Access Audit Site Report

Bentsen-Rio Grande Valley State Park

Accessibility Evaluation

Inspection Date: 07/13/2022

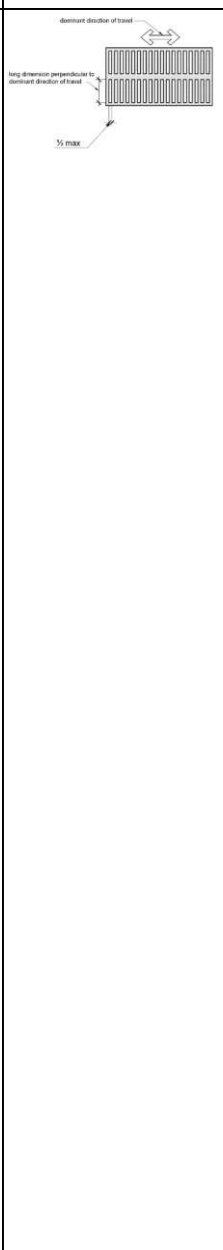
| Finding Number | Area Description | Lat/Long | Finding | As Built | Recommendation | Citation | Photos | Figure |
|----------------|-------------------------------------|--------------------------------------|--|--|--|--|---|---|
| 5 | Exterior: Exterior Accessible Route | [26.1766849 , -98.384670 7] | There is a gap spaced greater than a 1/2 inch. Openings in floor or ground surfaces shall not allow passage of a sphere more than 1/2 inch diameter. Elongated openings shall be placed so that the long dimension is perpendicular to the dominant direction of travel. | Paixtle Restroom - 1" gap at entry to women's, along front walkway - 1", 1", 1.5" gaps | Correct or fill gaps to be max .5". | 2015 ABAAS Section: 302.3 2012 TAS Section: 302.3 2010 ADAS Section: 302.3 |     |  |

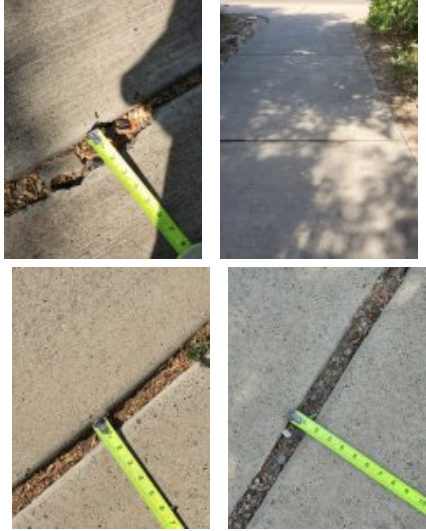
| Finding Number | Area Description | Lat/Long | Finding | As Built | Recommendation | Citation | Photos | Figure |
|----------------|-------------------------------------|-----------------------------|---|--|---|--|--|--------|
| 6 | Exterior: Exterior Accessible Route | [26.1767535 , -98.384639 8] | The change in level where the gutter meets the curb ramp is greater than 1/4 inch. 1/4 inch is the maximum vertical rise. Changes in level between 1/4 inch and 1/2 inch must be beveled at 1:2 or less. Changes in level greater than 1/2 inch must be by way of a ramp. | Paixtle restroom curb ramp - 11.9% slope, 37" width, 1.25" change in level | Replace curb ramp with one having max running slope 8.33%, max cross slope 2.08%, having a top landing as wide as the ramp and 36" deep and side flares with a max slope 10%. | 2015 ABAAS Section: 303.3 2012 TAS Section: 303.3 2010 ADAS Section: 303.3 |  | |

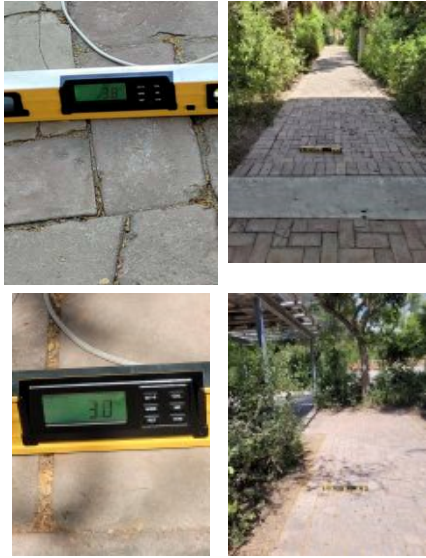
| Finding Number | Area Description | Lat/Long | Finding | As Built | Recommendation | Citation | Photos | Figure |
|----------------|-------------------------------------|-----------------------------|--|---|-------------------------------------|--|---|---|
| 12 | Exterior: Exterior Accessible Route | [26.1859832 , -98.379703 2] | There is a gap spaced greater than a 1/2 inch. Openings in floor or ground surfaces shall not allow passage of a sphere more than 1/2 inch diameter. Elongated openings shall be placed so that the long dimension is perpendicular to the dominant direction of travel. | six instances of gaps from HQ to bus pick up - 1.25", .75", 1", 2", 1", 1.25" | Correct or fill gaps to be max .5". | 2015 ABAAS Section: 302.3 2012 TAS Section: 302.3 2010 ADAS Section: 302.3 |       |  |

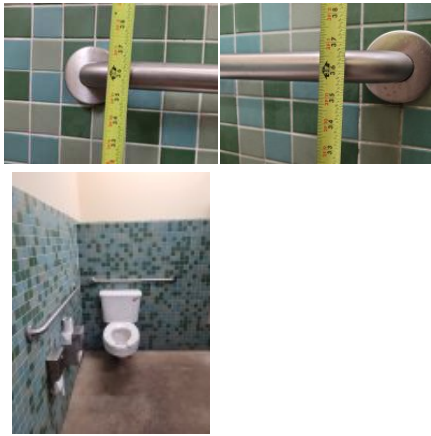
| Finding Number | Area Description | Lat/Long | Finding | As Built | Recommendation | Citation | Photos | Figure |
|----------------|-------------------------------------|---------------------------|---|--|--|--|--|---|
| 17 | Exterior: Exterior Accessible Route | [26.185485, -98.380779 2] | The accessible route of travel contains cross slopes greater than 2%. Cross slopes shall not exceed one unit vertical in 48 units horizontal (2-percent slope). | from park store to tram pick up - 3%, 2.7%, 3.9%, 3.5%, 3.7% | Correct or repair cross slope along AR to max 2.08%. | 2015 ABAAS Section: 403.3 2012 TAS Section: 403.3 2010 ADAS Section: 403.3 |  |  |

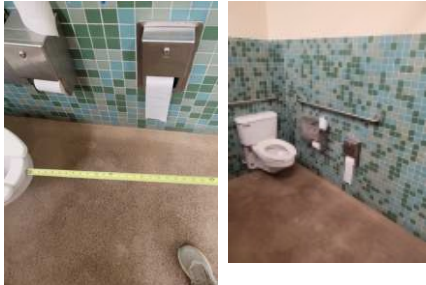
| Finding Number | Area Description | Lat/Long | Finding | As Built | Recommendation | Citation | Photos | Figure |
|----------------|---|-----------------------|---|---|---|---|--|---|
| 20 | Headquarters Area: HQ - Men's Restroom | [26.18571, -98.37984] | The urinal is located in an area that does not provide the required clear floor space for a front approach. The surrounding elements of a urinal must provide a minimum of 30 by 48 inches of clear floor space for a front approach. | cone in clear floor space for accessible urinal | Relocate storage to provide 30" x 48" clear floor space for urinal. | 2015 ABAAS Section: 605.2 2012 TAS Section: 605.2 2010 ADAS Section: 605.2 |  | |

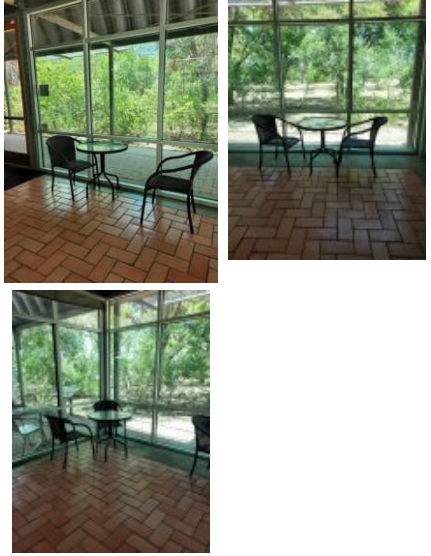
| Finding Number | Area Description | Lat/Long | Finding | As Built | Recommendation | Citation | Photos | Figure |
|----------------|---|-----------------------|---|--|---|--|---|---|
| 25 | Headquarters Area: HQ - Men's Restroom | [26.18571, -98.37984] | The stall door fails to comply with all of the door requirements. The stall door must be a minimum of 32" wide and have compliant hardware on both sides. The stall door must be self-closing. | lack hardware on push, not self closing | Adjust stall door to be self-closing. Replace stall hardware with hardware operable without a tight pinch or grasp on both sides of the stall door. | 2015 ABAAS Section: 404.2.3, 404.2.7, 604.8.2.2 2012 TAS Section: 404.2.3, 404.2.7, 604.8.2.2 2010 ADAS Section: 404.2.3, 404.2.7, 604.8.2.2 |  | |

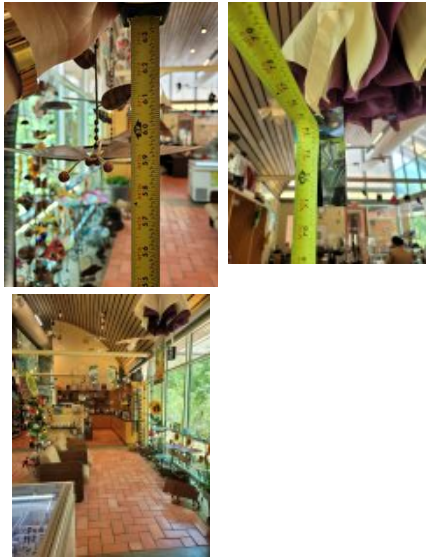
| Finding Number | Area Description | Lat/Long | Finding | As Built | Recommendation | Citation | Photos | Figure |
|----------------|--|-----------------------|--|--|--|---|---|---|
| 39 | Headquarters Area: HQ - Public Spaces | [26.18571, -98.37984] | The clear floor space required at accessible drinking fountains is not positioned for a forward approach. Units shall have a clear floor or ground space positioned for a forward approach and centered on the unit. | exterior fountain near restrooms - clear floor space 20" width due to missing pavers | Repair pavers in front of drinking fountain to provide a forward approach 30" X 48" CFS to the fountain. | 2015 ABAAS Section: 602.2 2012 TAS Section: 602.2 2010 ADAS Section: 602.2 |  |  |

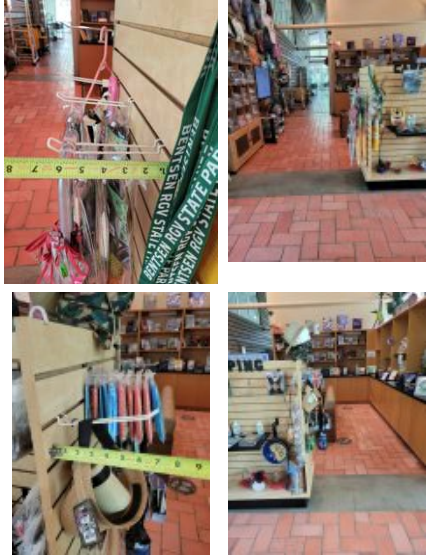
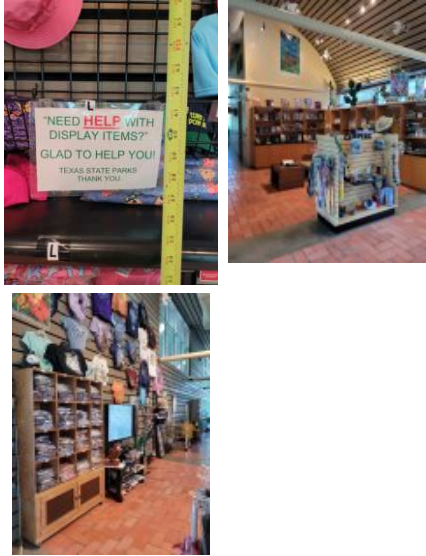
| Finding Number | Area Description | Lat/Long | Finding | As Built | Recommendation | Citation | Photos | Figure |
|----------------|--|-----------------------|--|---|--|--|---|--|
| 41 | Headquarters Area: HQ - Public Spaces | [26.18571, -98.37984] | The spout for the drinking fountain is too high. Spout outlets shall be 38 inches minimum and 43 inches maximum above the finish floor or ground for standing persons. | fountain at administrative restrooms - 46.5" above finished floor | Remount fountain for standing persons to 38" min and 43" max aff to the spout. | 2015 ABAAS Section: 602.7 2012 TAS Section: 602.7 2010 ADAS Section: 602.7 |  |  |
| 42 | Headquarters Area: HQ - Public Spaces | [26.18571, -98.37984] | The water flow from the spout is too low. The spout shall provide a flow of water 4 inches high minimum. | fountain at administrative restrooms - low flow | Adjust spout flow height to min. 4". | 2015 ABAAS Section: 602.6 2012 TAS Section: 602.6 2010 ADAS Section: 602.6 | |  |

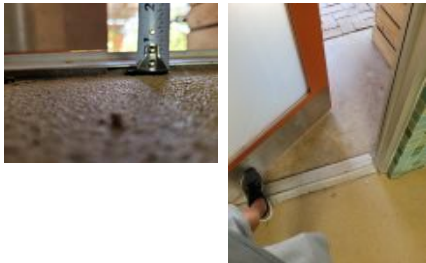
| Finding Number | Area Description | Lat/Long | Finding | As Built | Recommendation | Citation | Photos | Figure |
|----------------|---|----------------------|--|---|--|--|---|---|
| 81 | Headquarters Area: Administrative Restrooms - Women's Restroom | [26.18575, -98.3808] | The toilet paper is not installed within the compliant range in front of the toilet. Toilet paper dispensers shall be 7 inches minimum and 9 inches maximum in front of the water closet measured to the centerline of the dispenser. The outlet of the dispenser shall be 15 inches minimum and 48 inches maximum above the finish floor and shall not be located behind grab bars. Dispensers shall not be of a type that controls delivery or that does not allow continuous paper flow. There shall be a clearance of 1 1/2 inches minimum below the grab bar. | TP mounted too close and too far from the front of the toilet | Remount toilet paper dispenser max 7" to 9" from front of toilet, 15" to 48" aff and min 12" above or 1.5" below grab bar. | 2015 ABAAS Section: 604.7 2012 TAS Section: 604.7 2010 ADAS Section: 604.7 |  |  |

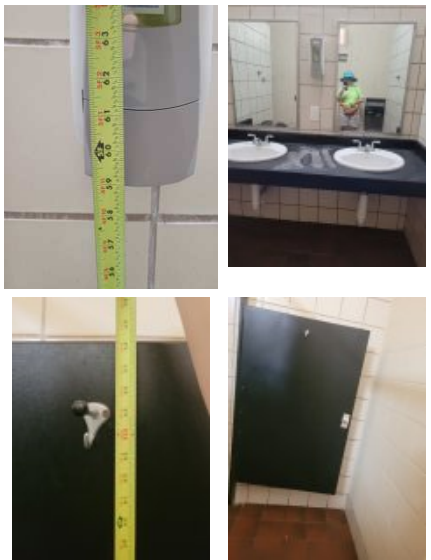
| Finding Number | Area Description | Lat/Long | Finding | As Built | Recommendation | Citation | Photos | Figure |
|----------------|--|--------------------------------------|--|-----------------------------------|--|--|---|---|
| 121 | Restrooms : Hackberry - Men's Restroom | [26.1773577 , -98.388519 6] | The top rim of the sink is too high. All lavatories/sinks that are designated to be accessible shall be a minimum 17 inches in horizontal depth and mounted with the rim or counter edge no higher than 34 inches above the finished floor. | rim 35.5" AFF | Lower sinks to max 34" above the finished floor (AFF) to front of rim. | 2015 ABAAS Section: 606.3 2012 TAS Section: 606.3 2010 ADAS Section: 606.3 |  |  |

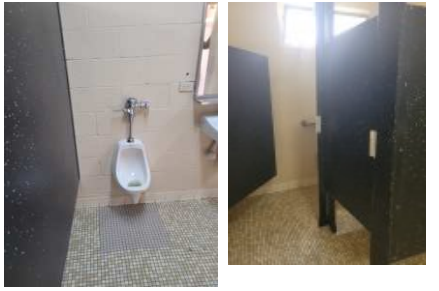
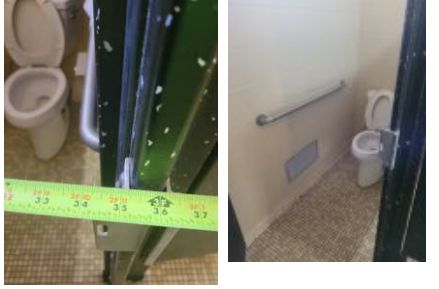
| Finding Number | Area Description | Lat/Long | Finding | As Built | Recommendation | Citation | Photos | Figure |
|----------------|---|--------------------------------------|--|----------------|--|--|--------|--------|
| 133 | Restrooms : Hackberry - Women's Restroom | [26.1773673 , -98.388519 6] | The top rim of the sink is too high. All lavatories/sinks that are designated to be accessible shall be a minimum 17 inches in horizontal depth and mounted with the rim or counter edge no higher than 34 inches above the finished floor. | rim 34.75" AFF | Lower sinks to max 34" above the finished floor (AFF) to front of rim. | 2015 ABAAS Section: 606.3 2012 TAS Section: 606.3 2010 ADAS Section: 606.3 | | |

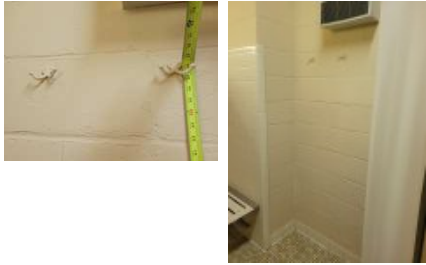
| Finding Number | Area Description | Lat/Long | Finding | As Built | Recommendation | Citation | Photos | Figure |
|----------------|--|--------------------------------------|--|---|---|--|---|--------|
| 148 | Restrooms : Paixtle - Men's Restroom | [26.1766692 , -98.384751 1] | The door to the ambulatory compartment swings into the minimum required compartment area. Toilet compartment doors shall not swing into the minimum required compartment area. | swings inward | Replace stall door of ambulatory stall with one that swings out and is self-closing. | 2015 ABAAS Section: 604.8.2.2 2012 TAS Section: 604.8.2.2 2010 ADAS Section: 604.8.2.2 |  | |

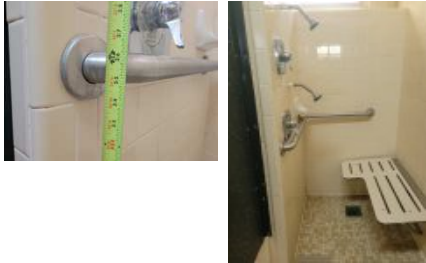
| Finding Number | Area Description | Lat/Long | Finding | As Built | Recommendation | Citation | Photos | Figure |
|----------------|---|--------------------------------------|--|--------------------------------|---|--|---|---|
| 152 | Restrooms : Paixtle - Men's Restroom | [26.1766632 , -98.384755 1] | The bench is not deep enough or long enough or is missing. Benches shall be provided having seats that are 42 inches long minimum and 20 inches deep minimum and 24 inches deep maximum. The bench shall provide for back support or shall be affixed to a wall. Back support shall be 42 inches (1065 mm) long minimum and shall extend from a point 2 inches (51 mm) maximum above the seat surface to a point 18 inches (455 mm) minimum above the seat surface. Back support shall be 2½ inches (64 mm) maximum from the rear edge of the seat measured horizontally. The top of the bench seat surface shall be 17 inches (430 mm) minimum and 19 inches (485 mm) maximum above the finish floor or ground. Clear floor or ground space complying with 305 shall be provided and shall be positioned at the end of the bench seat and parallel to the short axis of the bench | lacks bench | Acquire and install bench in dressing area having a seat depth of 20" to 24" deep, 42" long, affixed to the wall or having a back and mounted 17" to 19" aff and provide required clear floor space on the short axis of the bench. | 2012 TAS Section: 903.4, 903.2, 903.3, 903.5 2010 ADAS Section: 903.4, 903.2, 903.3, 903.5 |  |  |

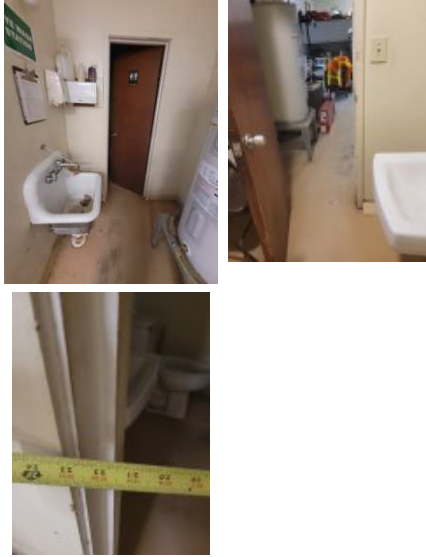
| Finding Number | Area Description | Lat/Long | Finding | As Built | Recommendation | Citation | Photos | Figure |
|----------------|---|-------------------------------|--|-------------|---|---|--|--|
| 165 | Restrooms : Paixtle - Women's Restroom | [26.1766596 , -98.3847592] | Transfer type shower compartments shall be 36 inches (915 mm) by 36 inches (915 mm) clear inside dimensions measured at the center points of opposing sides and shall have a 36 inch (915 mm) wide minimum entry on the face of the shower compartment. Clearance of 36 inches (915 mm) wide minimum by 48 inches (1220 mm) long minimum measured from the control wall shall be provided. | 37" depth | Reconfigure transfer shower to compliant 36" by 36" clear inside dimension. In the alternative, leave as is citing construction tolerance. | 2015 ABAAS Section: 608.2.1 2012 TAS Section: 608.2.1 2010 ADAS Section: 608.2.1 |  |  |

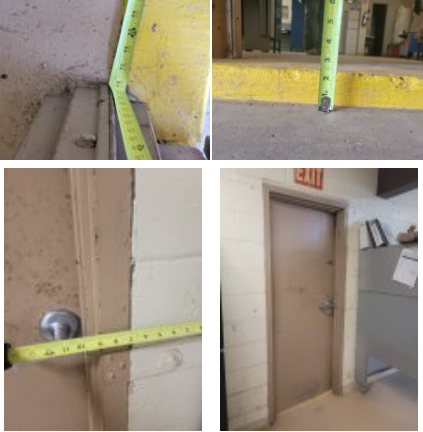
| Finding Number | Area Description | Lat/Long | Finding | As Built | Recommendation | Citation | Photos | Figure |
|----------------|---|--------------------------------------|--|---|---|---|---|--------|
| 167 | Restrooms : Paixtle - Women's Restroom | [26.1766596 , -98.384759 2] | The threshold has a vertical change greater than 1/4 inch high. The sweep period for doors with closers shall be adjusted so that from an open position of 70 degrees, the door will take at least 3 seconds to move to a point 3 inches from the latch, measured to the leading edge of the door. | Door - .75" change in level at door, fast close | For all doors along the public circulation route, repair, bevel, or ramp CILs at door entries to max .25". For all doors along the public circulation route, inspect, adjust, and maintain closing speed on door closers. | 2010 ADAS Section: 404.2.3, 404.2.7, 404.2.4, 404.2.11, 404.2.11 Exception |  | |
